# Access Compliance Report

## Public Rights-of-Way

### (Curb Ramps)

| Intersection ID: 50008 | Main Street: BERKELEY_PLACE_DR | Cross Street: SALERNO_DR | Location: N            |

| ADA ID: 75AC89E5B94F   | Ramp Type: PerpDiag            | Initial Pass/Fail: Fail  | Overall Compliance: No |

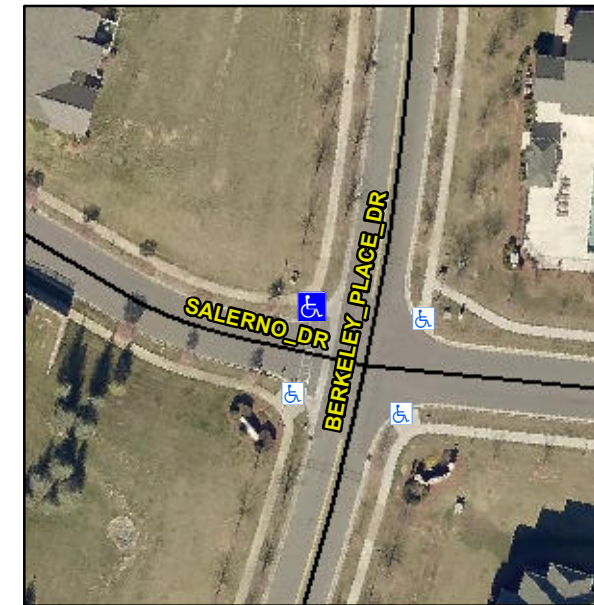
**R304.2.2, R304.5.3**

| Compliance | Description           | Data  | Compliance | Description                 | Data  |
|------------|-----------------------|-------|------------|-----------------------------|-------|
| N/A        | Ramp Length (in)      | 96.0  | No         | Ramp Slope (%)              | 20.0  |
| Yes        | Ramp Width (in)       | 52.0  | No         | Ramp XSlope (%)             | 4.0   |

**Remove & Replace Curb Ramp With Two New Directional Ramps or Equivalent.**
